## 1. Correction on the stalling mechanism

2. Addition of time-definite overcurrent protection to motor loads – Change of the reconnection time

## 3. Correction on the dq connection to the excitation system

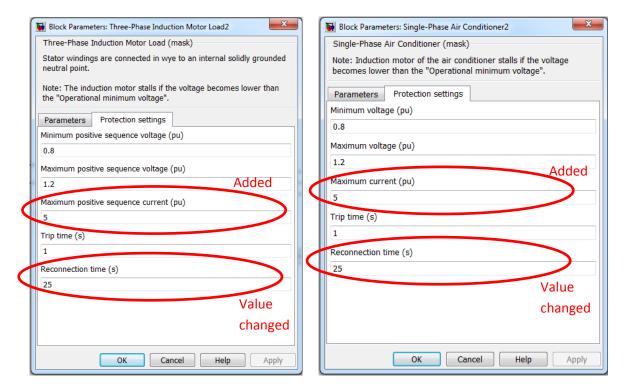
In all motor loads (both single- and three-phase) => in the block containing the stalling logic, that is:

=> the last part of the code has changed as shown below:

```
32 -
           if wR >= 0.75
33 -
               ifStalled = 0;
           else
34
35 -
               if (clock < (timerS
                                           32 -
                                                      if wR >= 0.75
36 -
                    ifStalled = 1;
                                           33 -
                                                           ifStalled = 0;
37 -
               elseif (clock >= (t
                                           34
38 -
                    isTimerOn = 0;
                                                      else
                                           35 -
                                                          if (clock < (timers
39
                    ifStalled = 1;
                                           36 -
                                                               ifStalled = 1;
40
               else
                                                           elseif (clock >= (t

41 -
                    ifStalled = 1;
                                           38 -
                                                               isTimerOn = 0;
42
               end
                                           39 -
                                                               ifStalled = 1;
43
           end
                                           40
                                                           end
44
      end
                                           41
                                                      end
45
                                           42
                                                 end
46
      end
```

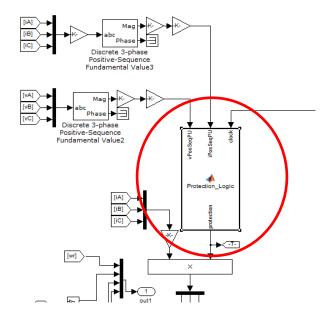
In all motor loads, the dialog box has changed to:

In all motor loads (single- and three-phase), time-definite overcurrent protection has been added. This means that if the output current goes above the limit (shown above) and stays there for at least the "Trip time" (shown above), the load disconnects.
